REMARKS

Claims 9–22 are pending in the above-identified application. Applicant have canceled claims 9–15, 17, 19, and 21, without prejudice. Applicant reserve the right to preserve those claims in a later-filed application. Applicant have also amended claim 16 in this application.

Fig. 1

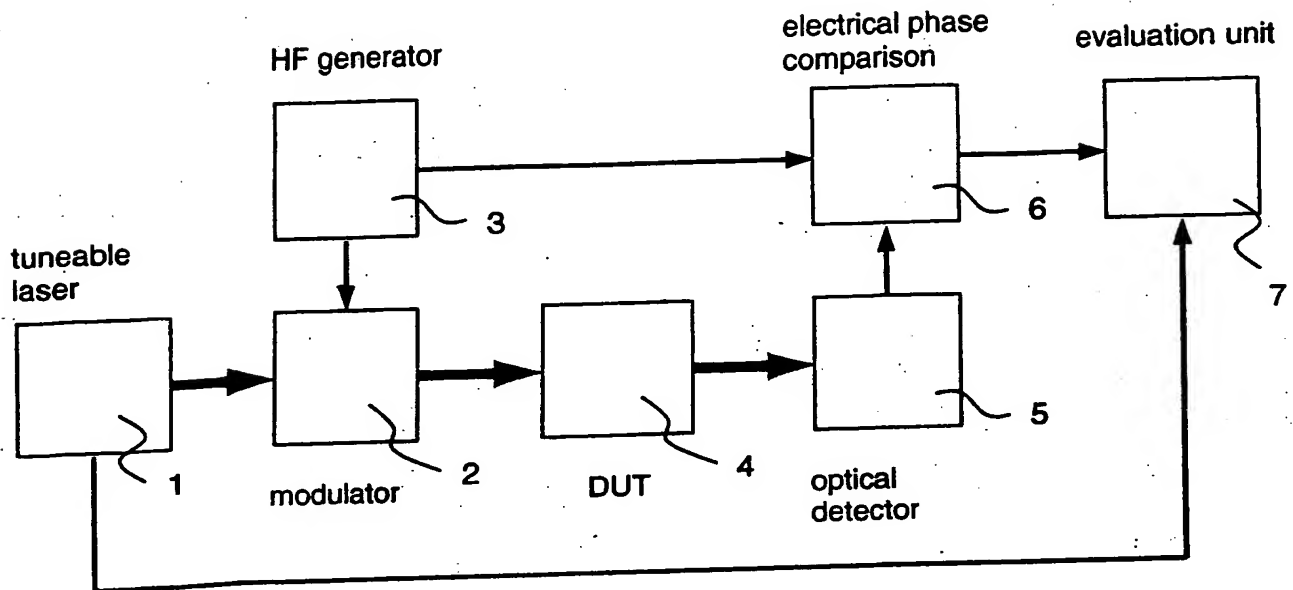
The drawings have been amended as suggested by the Examiner to identify Figures 1–3 as “Prior Art.” Replacement sheets as required by 37 C.F.R. § 1.84(c) are being filed with this response.

The attached sheets of drawings include the legend “Prior Art” in Figures 1, 2, and 3.

Fig. 3

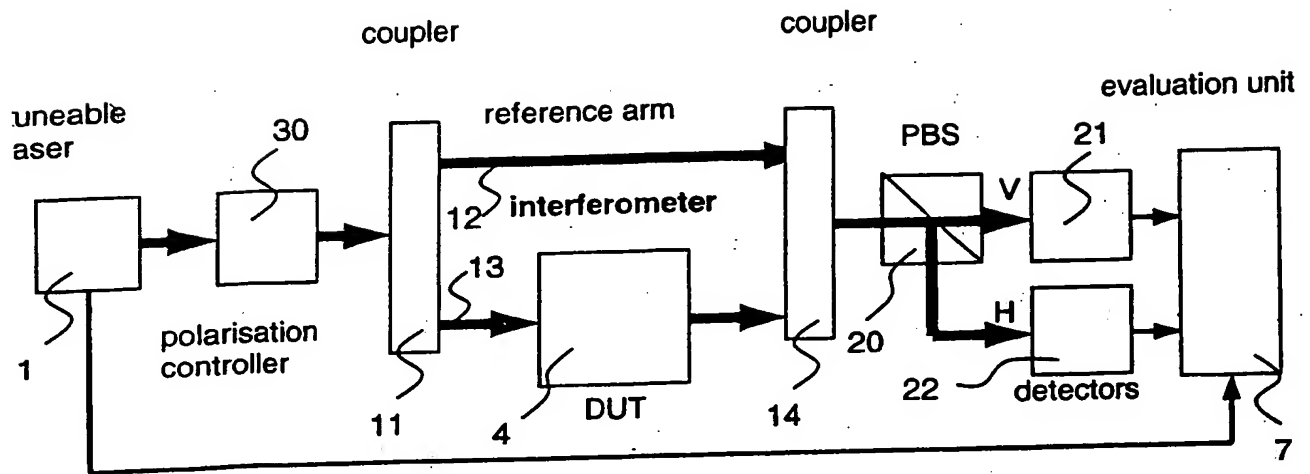
What the admitted prior art discloses is the provision of a polarization beam splitter PBS (see figure 3 of the present application, beam splitter indicated at 20). The polarization beam splitter includes two optical detectors. There is no polarimeter. The language of claim 17 indicates that two orthogonal states of polarization for determining the power changes are selected **using said polarimeter**. According to claim 17, the selection is to be made in such a manner that **power from the reference arm interferometer apparatus is broken down into virtual partial powers of approximately the same magnitude**. In other words, there is not real splitting of the beam in the reference arm. Rather, the two orthogonal states of polarization selected **at a later stage** behind the reference arm are selected in such a manner that the result is essentially the same as **if a virtual splitting in the reference arm had taken place**. That feature is explicitly described from page 5, line 23 to page 6, line 13 of the present application.

The present invention goes beyond the prior art admitted in Figure 3 of the present application because while Figure 3 relates to a real beam splitting, the present invention relates to a virtual beam splitting.
